IMPORTANT FIELD SAFETY NOTICE

PRODUCT: XVI R3.5, R4.0, R4.2, and R4.5

FCO Ref: 200 01 507 071

Different DICOM RT structures with the same name show incorrectly in XVI

Figure 2: The two different volumes change into one volume in XVI

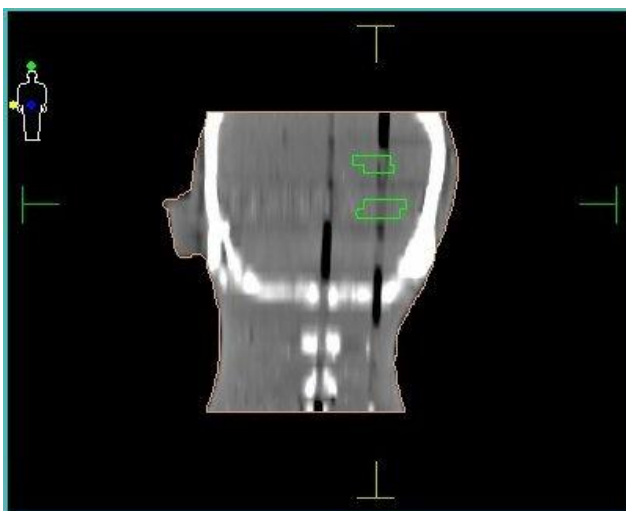
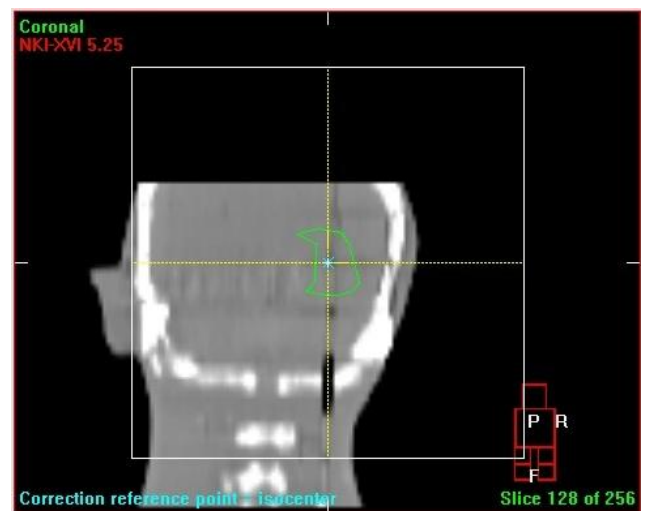
Problem: In some treatment planning systems (TPS), you can contour more than one region of interest with the same structure name. The DICOM tags do not contain sufficient information for XVI to identify the different volumes that have the same name. Therefore, if you use DICOM RT to send these volumes as one list of contours, it can cause XVI to:

- Interpolate a contour that identifies the two structures as one structure.
- Change the contour shape of the volumes in the imported CT reference data and structure sets.

Example 1: XVI changes the contour to identify the two structures as one structure. In this example, the two initial volumes are in line with each other.

Solution: In the TPS, give the different volumes different structure names.

After you import the patient data set from the TPS, make sure that the structure contours are correct.

Figure 4: The shape of the contours changes in XVI

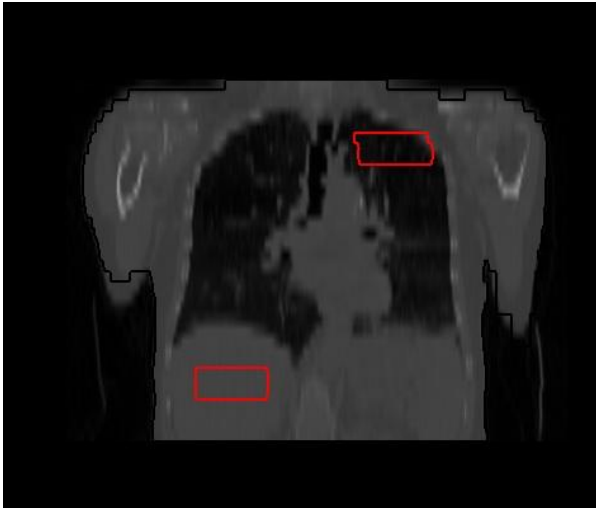
Example 2: XVI does not make one contour from the two contours, but it does change the shape of the two contours.

TPS usually show structure sets as a sequence of points on the axial CT slices. When these CT slices are imported into XVI and reconstructed into a 3D volume, XVI uses interpolation and triangulation algorithms to show the structure sets in 3D space in the VolumeView™ window. Assumptions are made in the interpolation procedure that are not always correct, and this can cause unusual results.
